HURRICANE CITY UTAH

Hurricane Planning Commission Meeting Agenda

September 26, 2024
6:00 PM

Agenda Date:	09/26/2024
Application Number:	AFP24-10
Type of Application:	Amended Final Plat
Action Type:	Administrative
Applicant:	Western Commercial Real Estate, PLLC
Agent:	Joseph Venuti
Request:	Approval of an Amended Final Plat.
Location:	2800 W 100 N
Zoning:	MH/RV
General Plan Map:	Single Family
Recommendation:	Continue this item.
Report Prepared by:	Fred Resch III

DATE: 3/26/2024
 DB NO.: 10361-22-012
 DESIGNED BY: JLW
 CHECKED BY: RMA
 WG: Canyons RV Amd 24

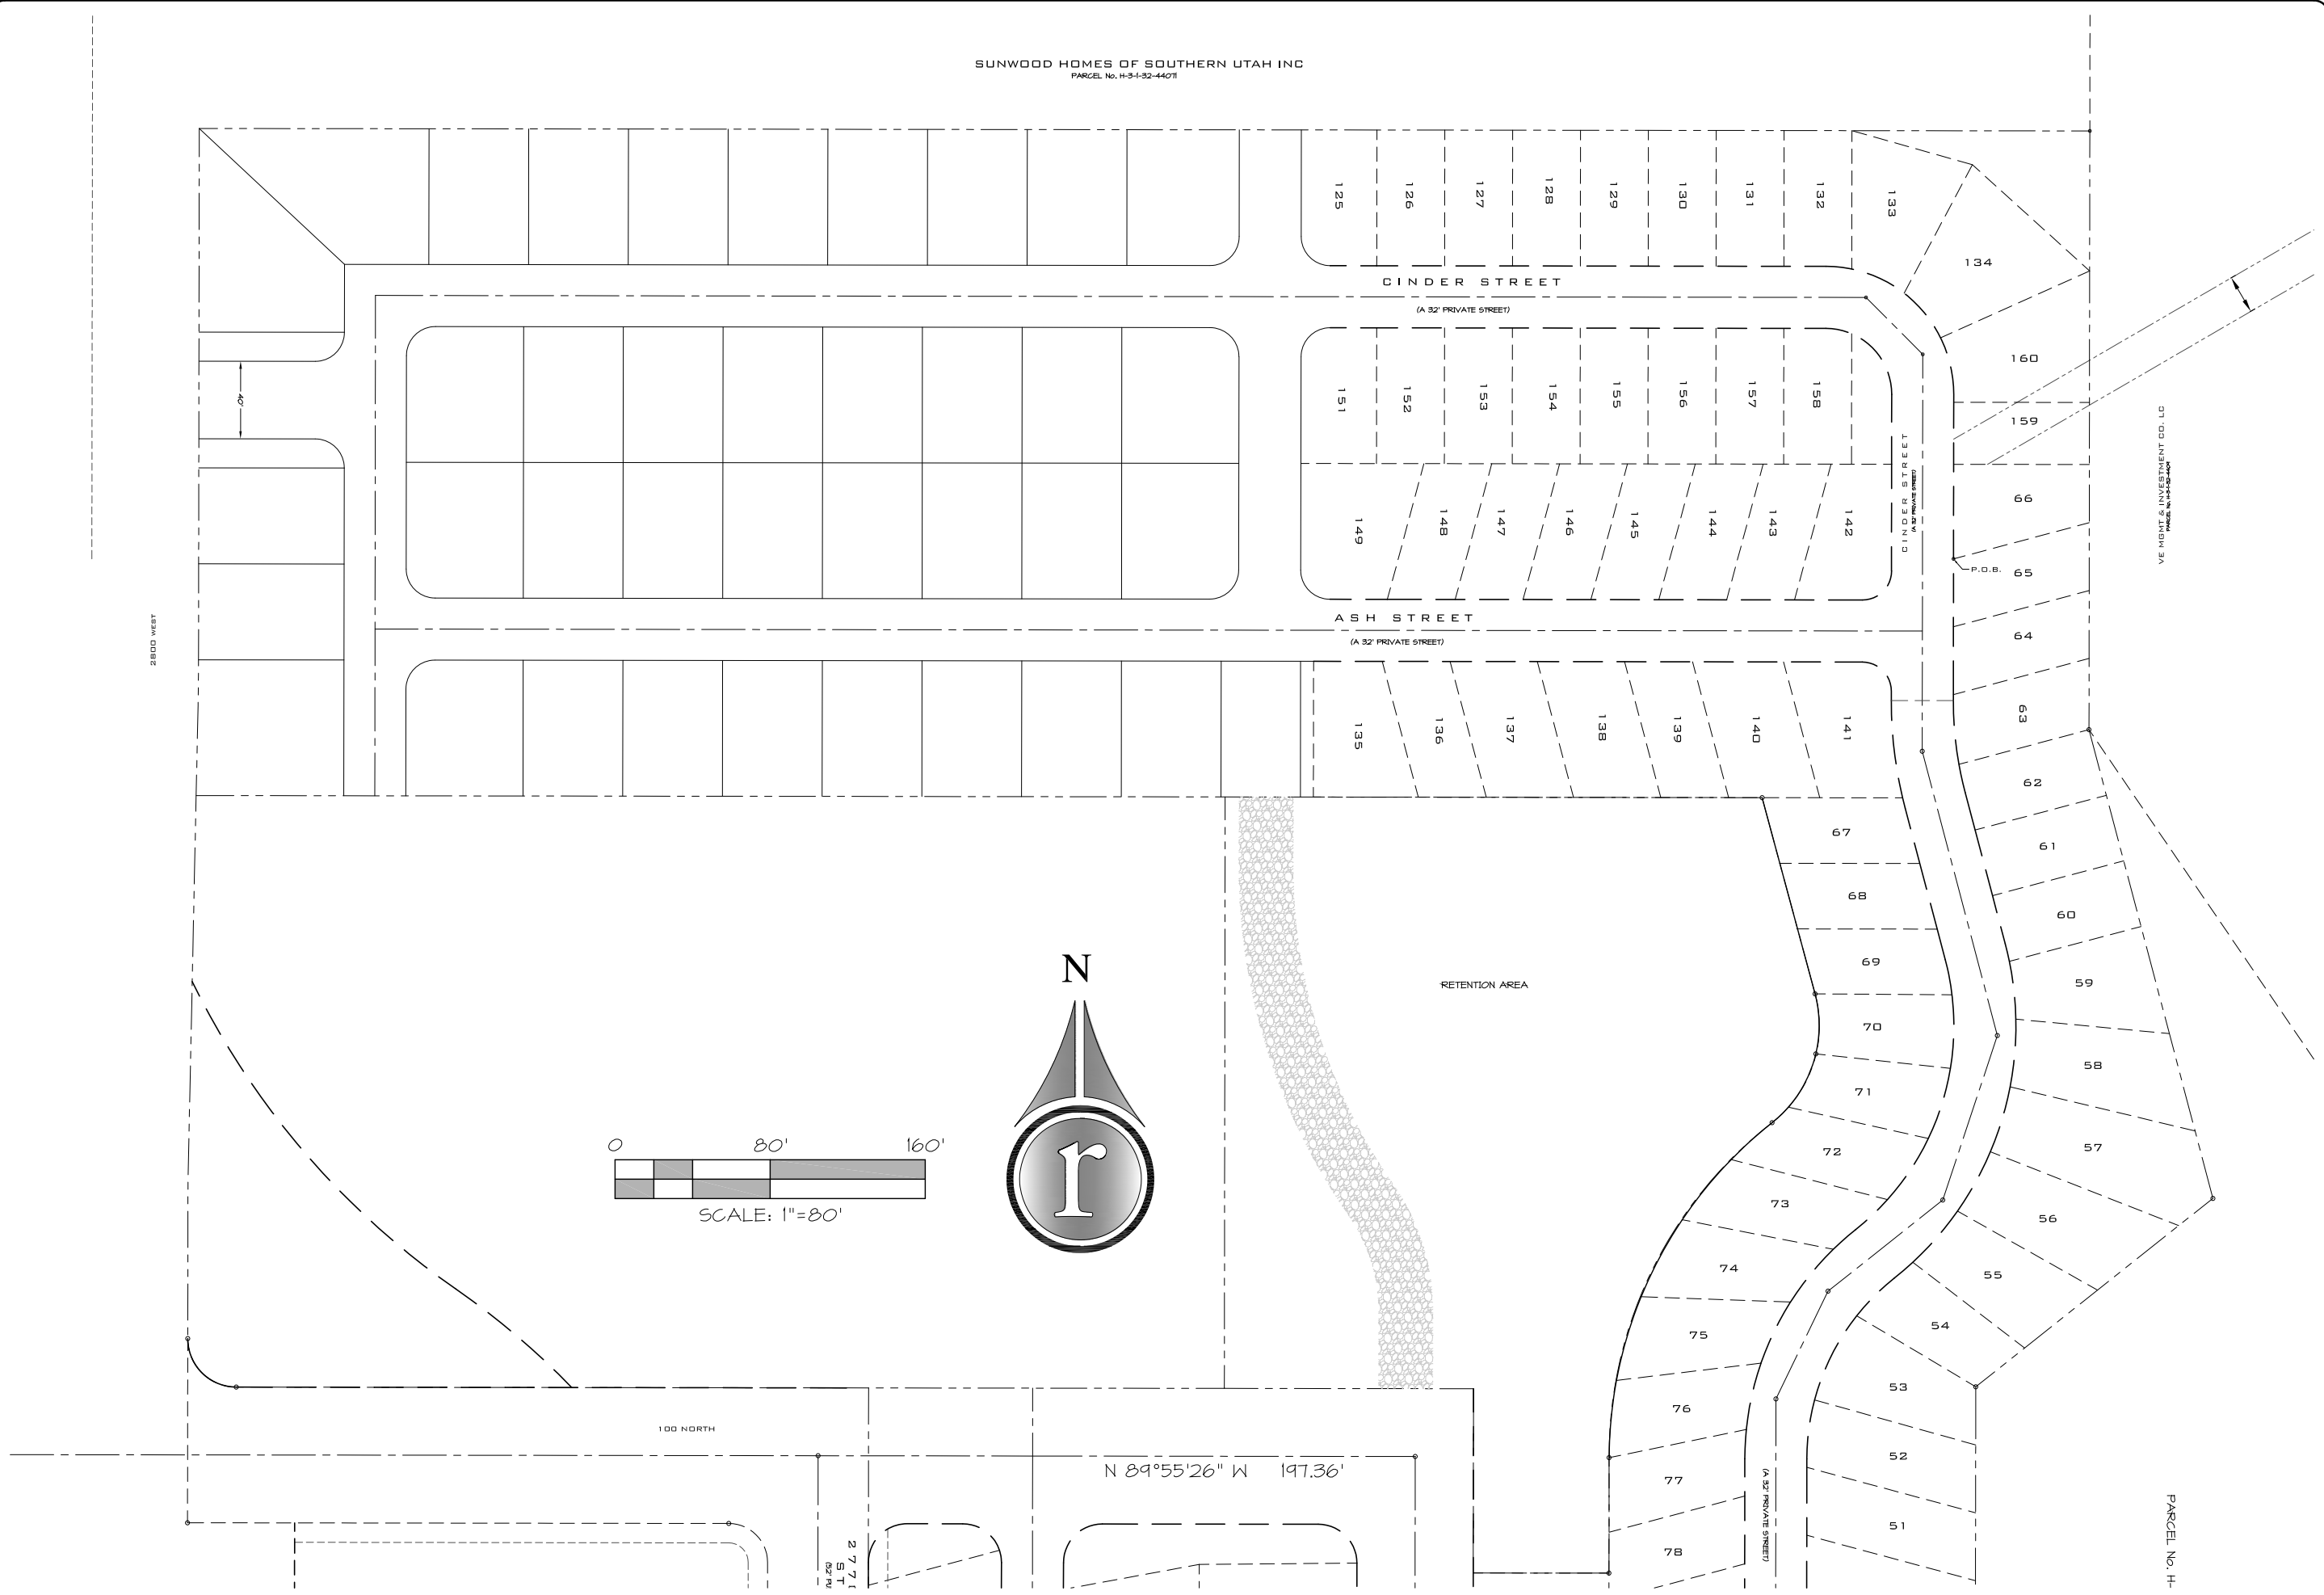
- 1. Public Works:** Must provide a public utility easement in the current Black Rock Road alignment or an approved alternative. Must connect to Sunwood Homes property. Need to make sure that all property owners in the area are aware of this amendment and have agreed to the submission of this application.

6. **Sewer:** Existing public utility easements need to remain.
7. **Fire:** Approved.
8. **Cable:** Facilities in the area. Please blue stake.
9. **Fiber:** Add Infowest notes.
10. **Gas:** Show Black Rock Road needs PUE to remain. Will gas be installed?
11. **WCWCD:** No comment.

- 5. Black Rock Road is a currently platted but undeveloped private roadway with a public utility easement. This PUE will need to be maintained or explicitly shown to be moving to a new location with this plat.

Recommendation: The Planning Commission should review this application based upon standards within the Hurricane City Code and State Code standards. Staff recommends continuing this item to allow the applicant time to provide additional information to address staff and JUC comments.

PRELIMINARY PLAT
STRAWBERRY FIELDS

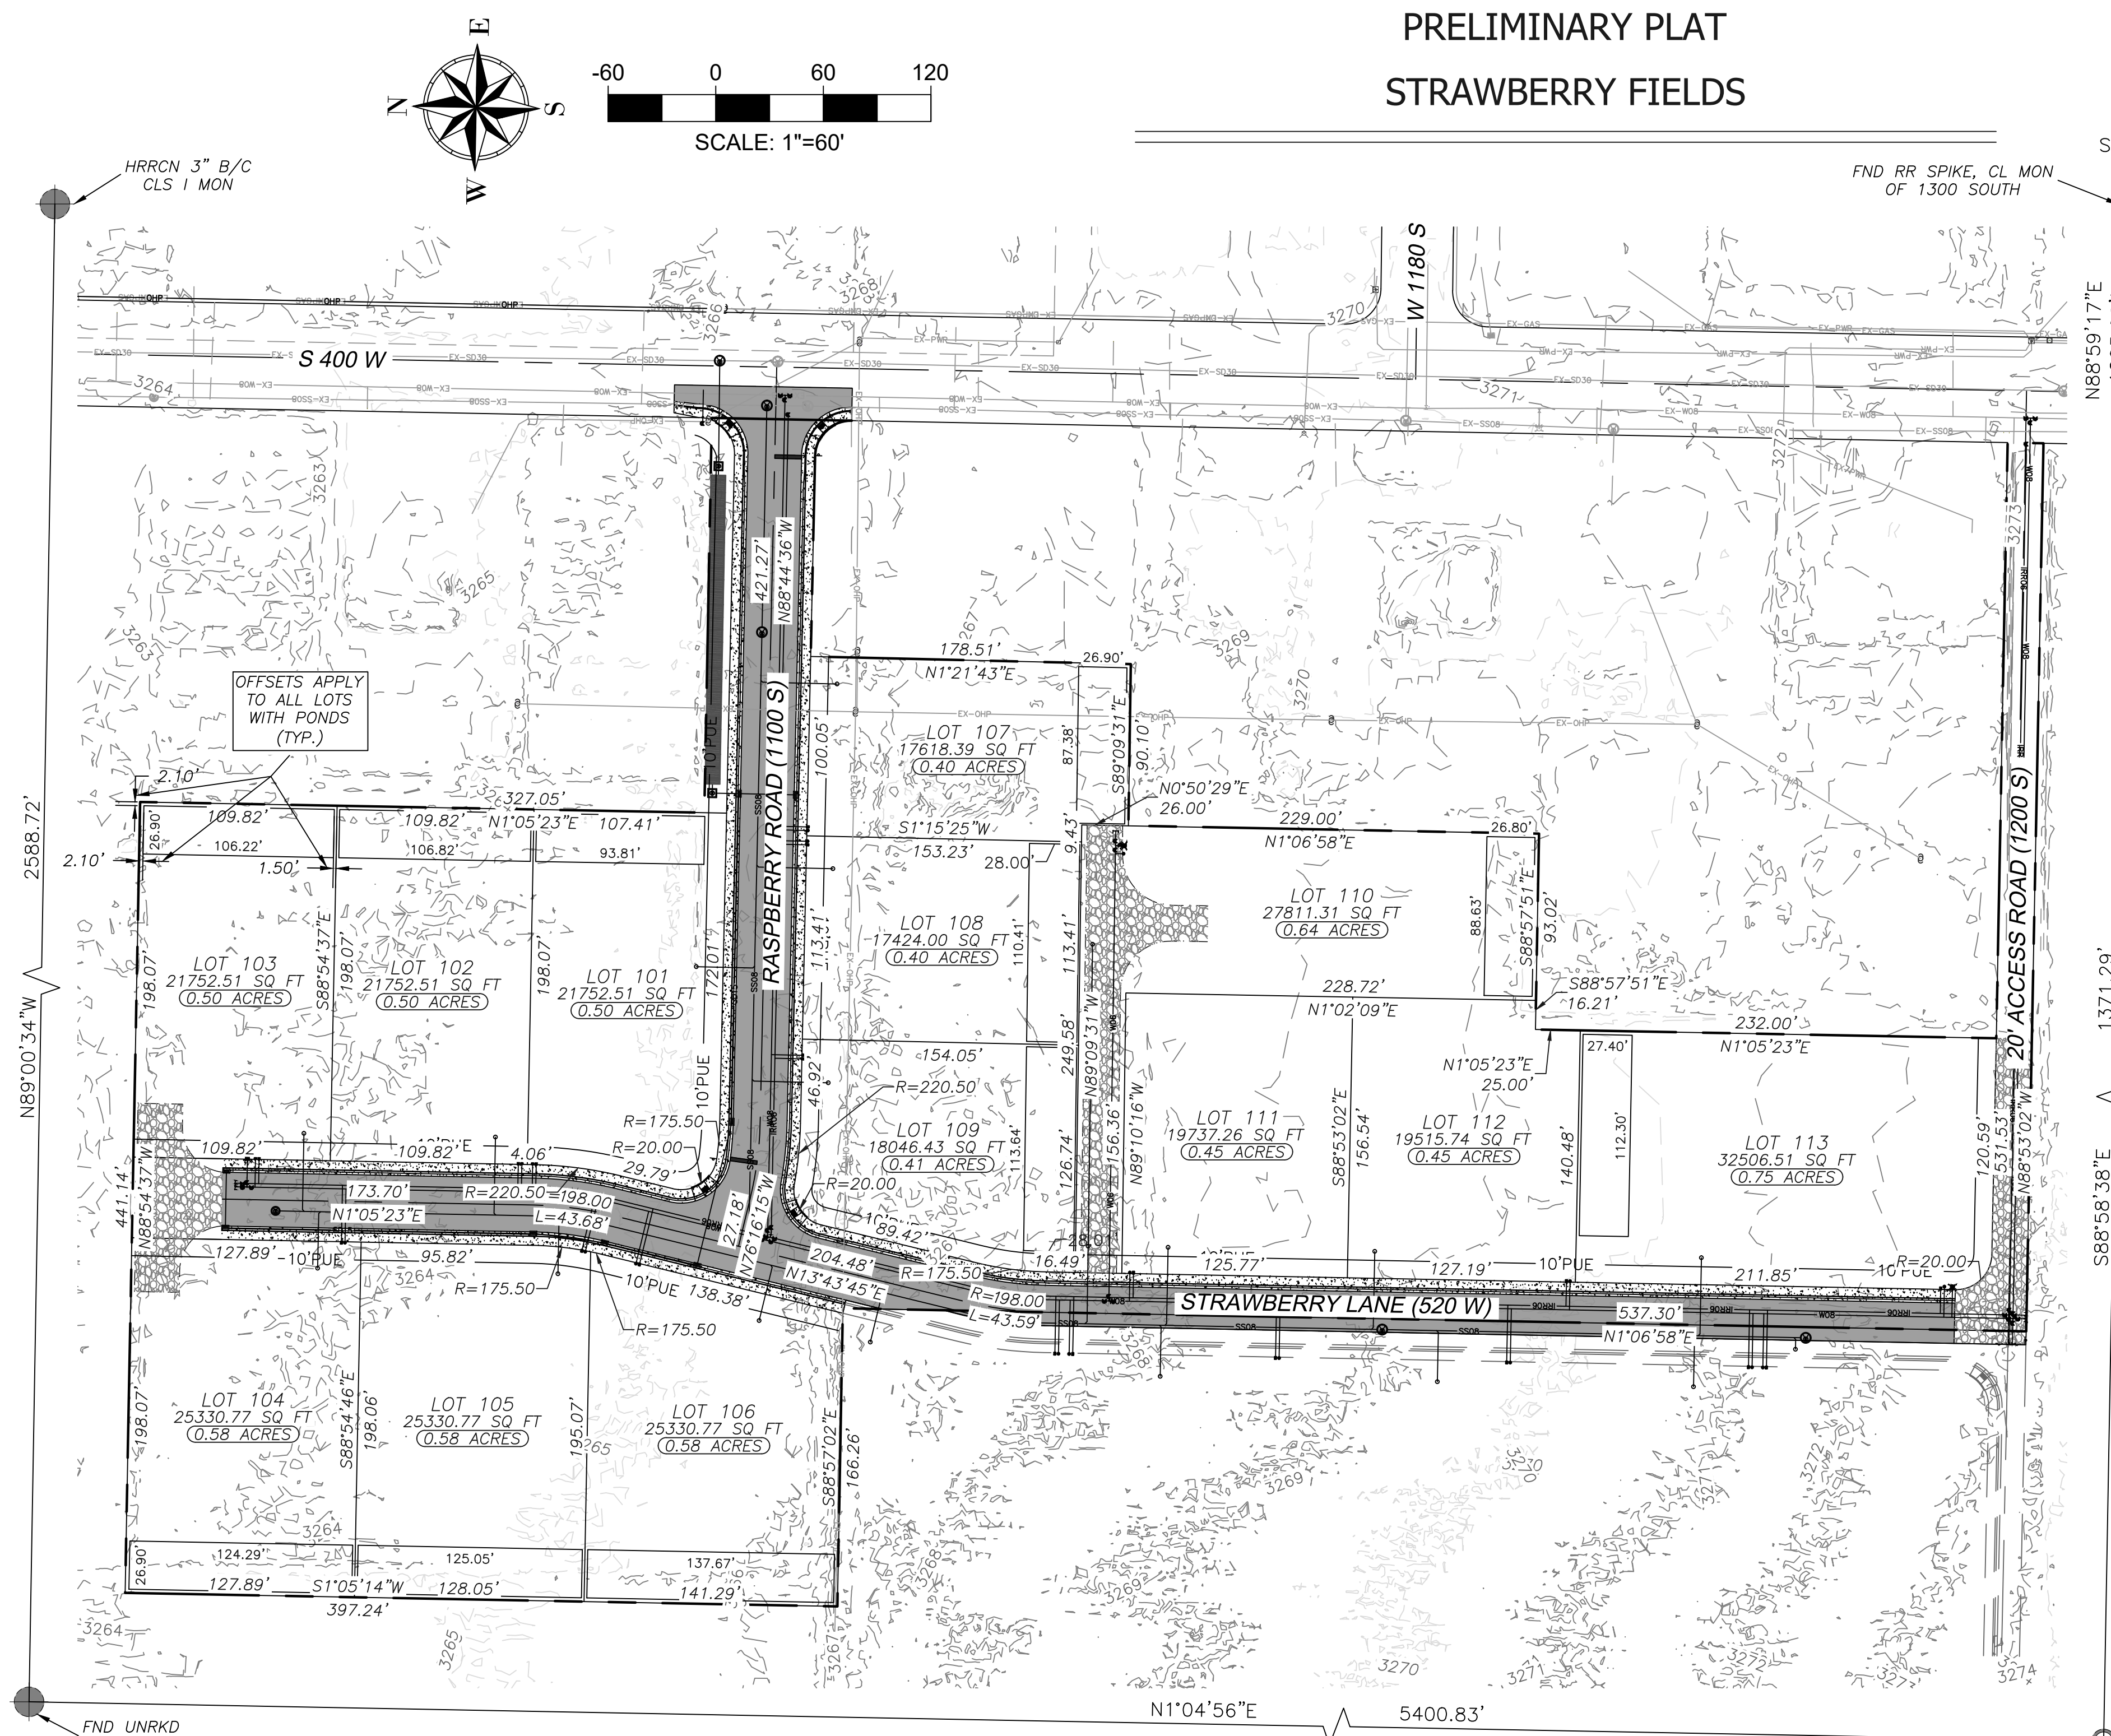
1. **Public Works:** Need to complete frontage improvements along 400 W and property dedications are needed. Need drainage study and a plan for drainage. Utilities need to stub past or to the property line and outside of asphalt. Access to lot 110 needs to be improved and paved.

5. **Water:** Need phase valve by water caps.
6. **Engineer:** Engineering would recommend to the Planning Commission that they continue the proposed Preliminary Plat until (1) the applicant can present to them agreements for their southern and western boundaries, (2) preliminary approval of the proposed plan from the Hurricane Canal Company is provided, and (3) engineering and planning can explain the Johnson's intentions for their property. Engineering would encourage coordinating with the Hurricane Canal Company early on to understand the existing irrigation system (HCS 3.8.1). The existing conditions and demolition plan should specify where irrigation water originates from and where tailwater flows to. The existing ditch between the applicant's property and Johnson's property isn't called out. "Any use of, alteration of, or relocation of structures on any irrigation ditch (or canal) shall have the written approval of the irrigation company." - HCS 3.4.10.2 Applicant should present said approval. 400 W is a master planned 60' minor collector. It appears the subdivision's easternmost boundary is the east line of lots 8 & 9 of the Hurricane Field Survey. If so, the typical back of sidewalk should be 13.5' from the existing property line. The proposed water and irrigation connections must fall in their standard locations (HCS 2.2.9(e)) in a planned public street (HCS 3.6.8.1). Engineering suggests that an agreement with the neighboring property owners (parcels H-3-2-3-2332, H-3-2-3-23131, H-3-2-3-23132, & H-3-2-3-2314 or H-3-2-3-2314 only, depending on the proposed streets width and location) is necessary for the preliminary plat (HCC 10-39-7(c)(10)). Applicant must solemnize the fire access turnarounds on lots 103, 104, & flag lot 110 and access to the fire hydrant on flag lot 110 by easement (HCS 10-37-10(b)(6)). The applicant should clarify their agreement with the property owners to the west, H-3-2-3-23193, or the Johnsons should clarify the agreement, for city staff. It appears utility stubs are being provided in exchange for their property (public right of way and utility easement).

7. **Fire:** Need correct scale. Need hydrants on the interior of the project.
8. **Cable/Phone:** TDS has utilities in this area. Please blue stake.
9. **Gas:** Existing 8" gas main in road. Need PUE for Lot 110.

3. Approval of this preliminary plat will not be considered approval of the proposed lots designated as "Future Lots to be Developed by Others."
4. As mentioned in the JUC comments above, the proposed plat shows roadway and access improvements on property owned by individuals other than the applicant. HCC 10-39-7(C)(10) states: *Where necessary, copies of any agreements with adjacent property owners relevant to the proposed subdivision shall be presented to the Planning Commission.*

- b. This subdivision is proposing access and utility improvements on property in an agricultural protection area. Notwithstanding the comments in Staff Comment #4, the property owner to the west may request this property be taken out of the agricultural protection area pursuant to HCC 10-21-7.
6. Will-serve letters from Hurricane City Water and Ash Creek Sewer District have been provided.
7. **Water use:** The Washington County Water Conservancy District has a county-wide tracking budget of approximately 75,000 units with approximately 20,000 units being located within Hurricane City. Approval of this preliminary plat will add 13 units to Hurricane City's total.
8. The name of this subdivision should be changed to avoid confusion with the similarly named "Strawberry Fields Estates" subdivision under development.

Recommendation: The Planning Commission should review this application based upon standards within the Hurricane City Code and State Code standards. Staff recommends this item be continued to allow the applicant to address staff and JUC comments.
